East Broad Market Lofts PUD 20180408 Proposed Master Plan and PUD Changes

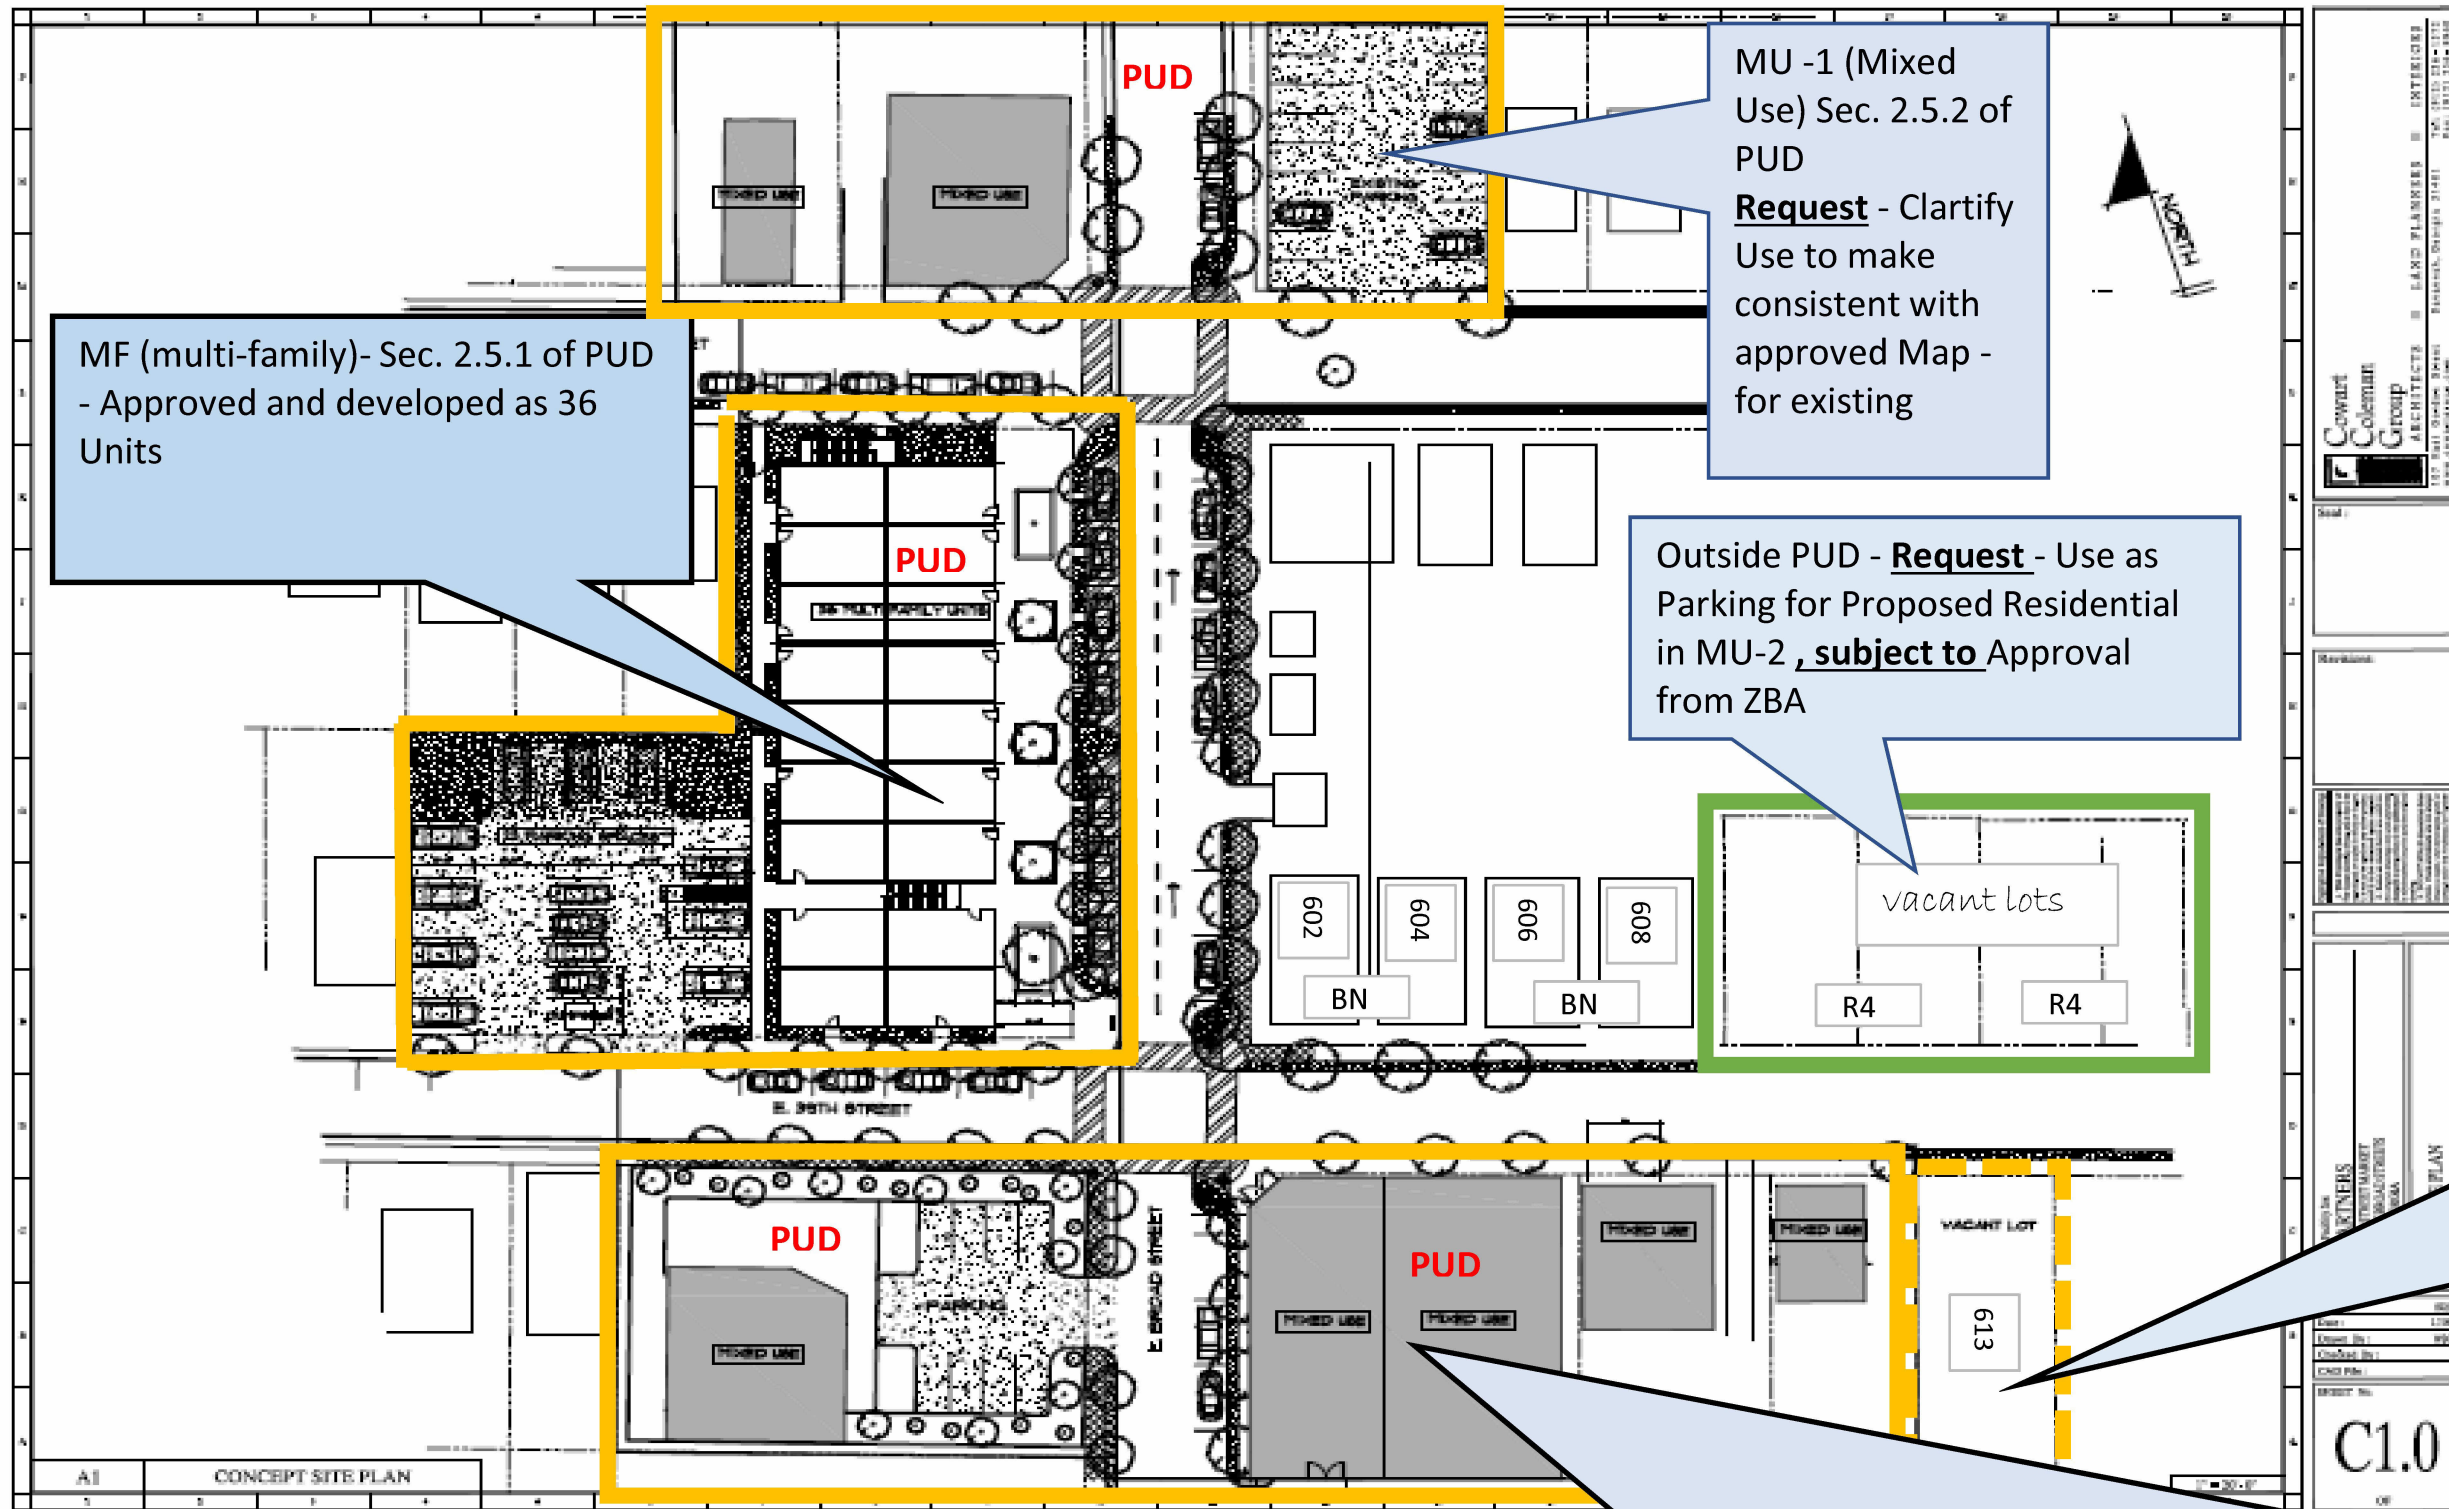
MU -1 (Mixed Use) Sec. 2.5.2 of PUD
Request - Clarify Use to make consistent with approved Map - for existing

Outside PUD - **Request** - Use as Parking for Proposed Residential in MU-2 , **subject to** Approval from ZBA

Request lot 613 be added to existing PUD under proposed Sec 2.5.2 MU 2 designation

MU -2 (Mixed Use) Sec. 2.5.2 of PUD **Request** -

1. Alter MU-2 for same density as MF 2.5.1 (36 units)
2. Allow ground floor residence same as MF 2.5.1
3. Substitute the parking requirements with those same parking provisions contained in Sec. 8-3224 Parking - Mid-City Zoning Ordinance

SUBJECT TO - Plan Site Review and Approval showing proposed parking (including design and landscaping of proposed parking lot) AND Review and Approval of the facade design (including building material) ; building layouts and location (no building to exceed 5k sf footprint as recommended by MPC); hardscape and landscaping.
